**Device**            **C164CM-4EF**  
**Marking/Step**   **Step (E)ES-AB, AB**  
**Package**           **P-TQFP-64**

This Errata Sheet describes the deviations from the current user documentation.

Figure 1 Additional Jitter

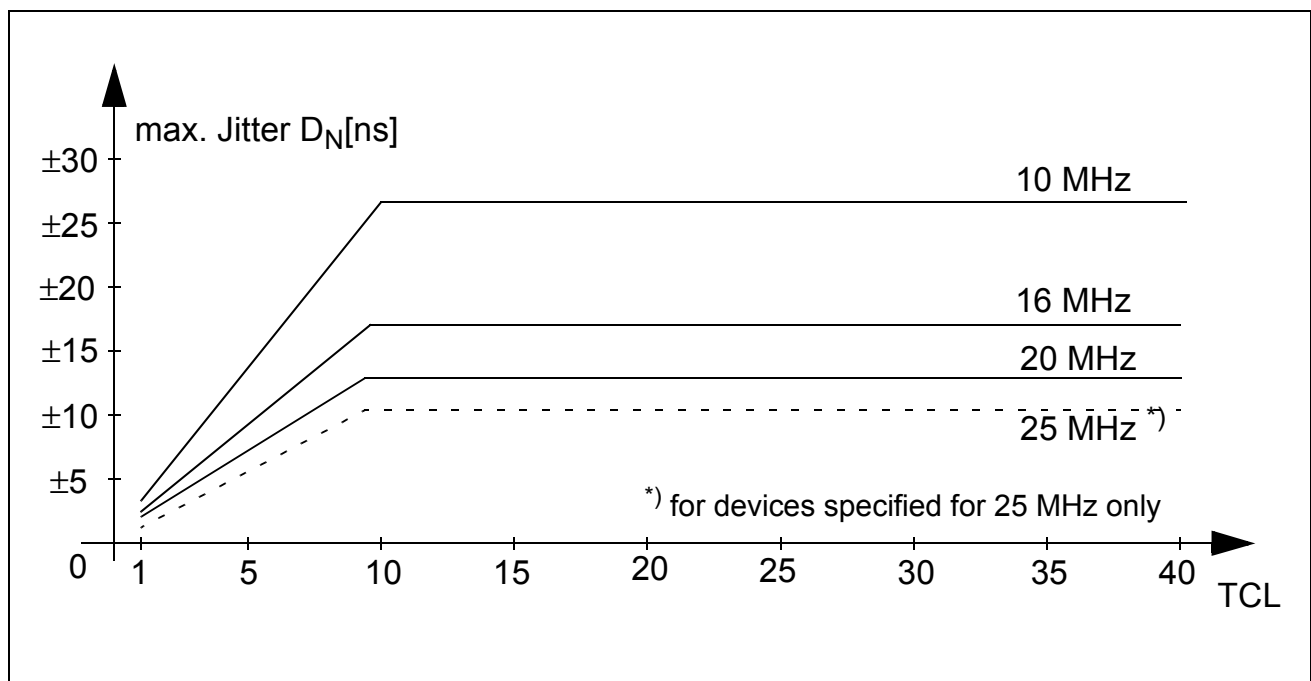
### **PLL.3.6 Increased PLL Jitter caused by external Access**

In systems where the PLL is used for generation of the CPU clock frequency, the PLL jitter can increase in certain circumstances and exceed the specified value.

The value of the additional jitter is not a fixed one but it depends on the kind of activity on the external bus or output pins. The additional jitter increases with the number of output/bus pins which are switched at the same time to a new voltage level because the problem is caused by noise on the on-chip power supply.

For an accumulated period of N\*TCL the new maximum jitter  $D_N$ [ns], which exceeds the specified value in the Data Sheet, is computed using the formula:

$$D_N[\text{ns}] = \pm(266 / f_{\text{CPU}}) * N / T_m$$

Were N = number of consecutive TCL,  $f_{\text{CPU}}$  = CPU frequency in MHz and  $T_m = 11.3 - f_{\text{CPU}} * 0.13$ . This approximated formula is valid for a CPU frequency  $10 \text{ MHz} \leq f_{\text{CPU}} \leq 20 \text{ MHz}$  with the conditions:

The accumulated jitter is in the specified range for accumulated periodes longer than N = 40 TCL.

In the case that the additional jitter causes problems in the system which cannot be relaxed with software adapted timing parameters the following workarounds are possible:

- If the clock generation is done with the on-chip oscillator then direct drive- or prescaler mode can be used.
- If the maximum frequency of the on-chip oscillator is not sufficient then an external clock generator can be used.

**Figure 2 Critical Event**

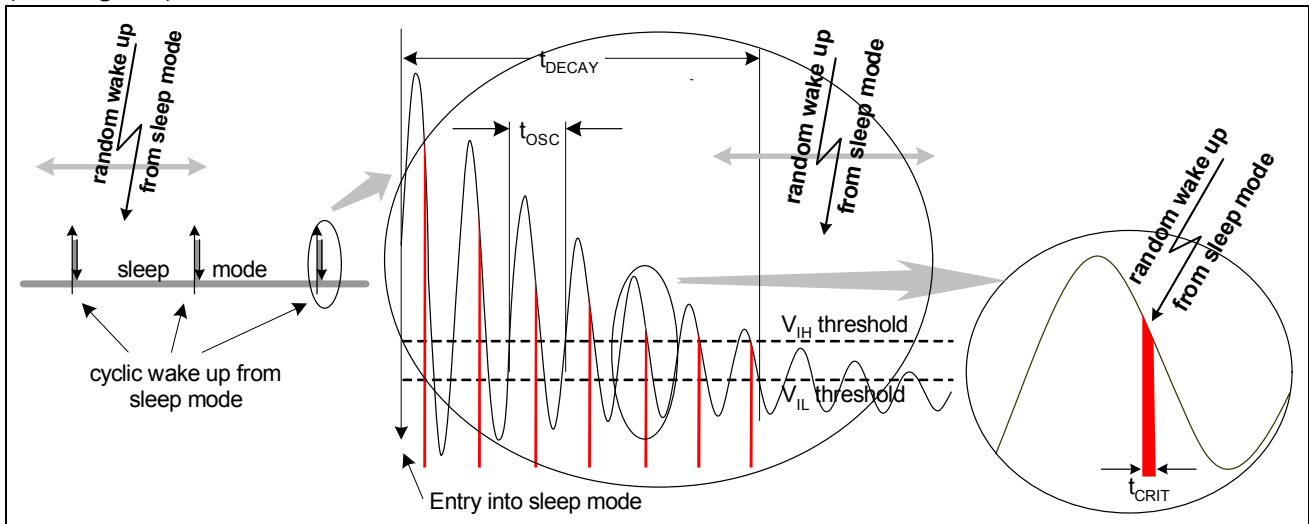
**POWER.22 Wake up from Sleep Mode in Oscillator Decay Time**

Due to a synchronization problem, the device may not correctly wake up from sleep mode if an asynchronous external wake up trigger occurs already in the oscillator decay time, i.e. in a particular time window before the device has actually entered sleep mode (see figure)

This problem may occur when all of the following conditions are met at the same time:

3. the external wake up trigger signal (fast external interrupt or signal on pin  $\overline{\text{NMI}}$ ) coincides with the critical time window ( $t_{\text{CRIT}}$ ) of each oscillator cycle during the decay time of the clock signal at pin XTAL1 (critical times shown in red in figure)

The problem occurs only in the decay time of the main oscillator and in a very small window around the clock edge at XTAL1 ( $t_{\text{CRIT}}$  is about 5 ps wide).

- Select RTC on in sleep mode (SYSCON1.SLEEPCON = 01<sub>B</sub>).  
For devices with auxiliary oscillator (e.g. C161CS), select main oscillator as clock source (SYSCON2.RCS = 0).
- Avoid a wake up during the main oscillator decay time

**Figure 3 SSCTB Timing**

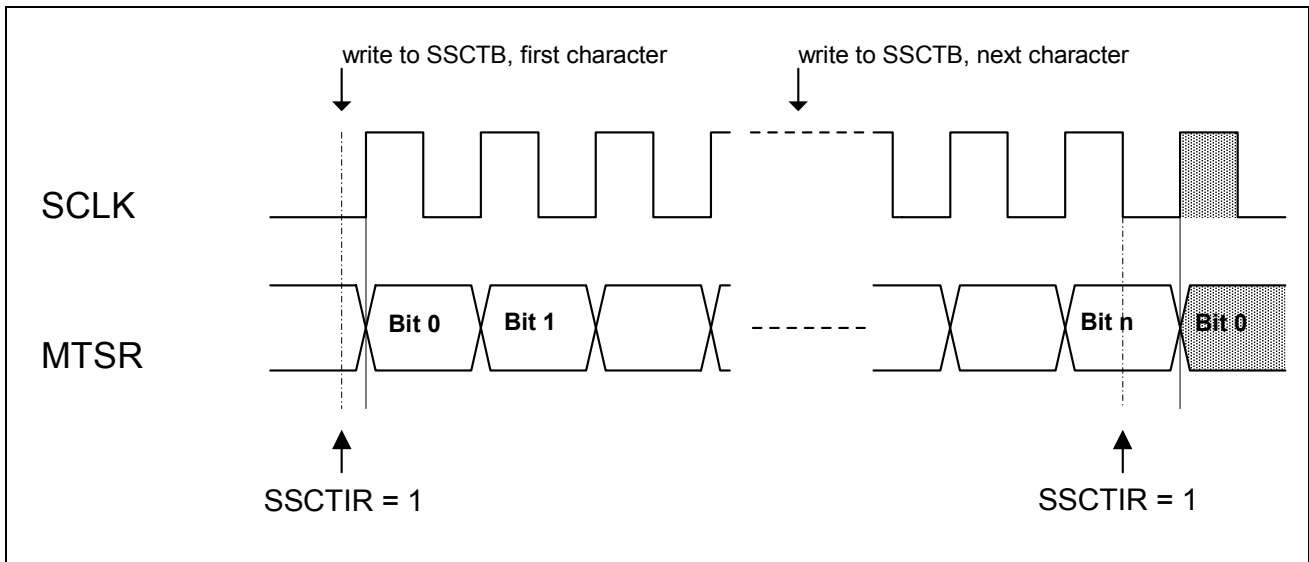
### **SSC.H2 Timing of flag SSCTIR (SSC Transmit Interrupt Request)**

When SSCTB has been written while the transmit shift register was empty (and the SSC is enabled), flag SSCTIR is set to '1' directly after completion of the write operation, independent of the selected baud rate. When the transmit shift register is not empty when SSCTB was written, SSCTIR is set to '1' after the last latching edge of SCLK (= 1/2 bit time before the first shifting edge of the next character). See also e.g. C167CR User's Manual V3.1, p. 12-5.

The following diagram shows these relations in an example for a data transfer in master mode with SSCPO = 0 and SSCPH = 0. It is assumed that the transmit shift register is empty at the time the first character is written to SSCTB:

Typically, in interrupt driven systems, no problems are expected from the modified timing of flag SSCTIR. However, when flag SSCTIR is polled by software in combination with other flags which are set/cleared at the end or at the beginning of a transfer (e.g. SSCBSY), the modified timing may have an effect.

Another situation where a different system behaviour may be noticed is the case when only one character is transferred by the PEC into the transmit buffer register SSCTB. In this case, 2 interrupt requests from SSCTIR are expected: the 'PEC COUNT = 0' interrupt, and the 'SSCTB empty' interrupt:

In order to achieve a defined and systematic behavior with all device steps, the SSC receive interrupt, which is generated at the end of a character transmission, may be used instead of the SSC transmit interrupt.
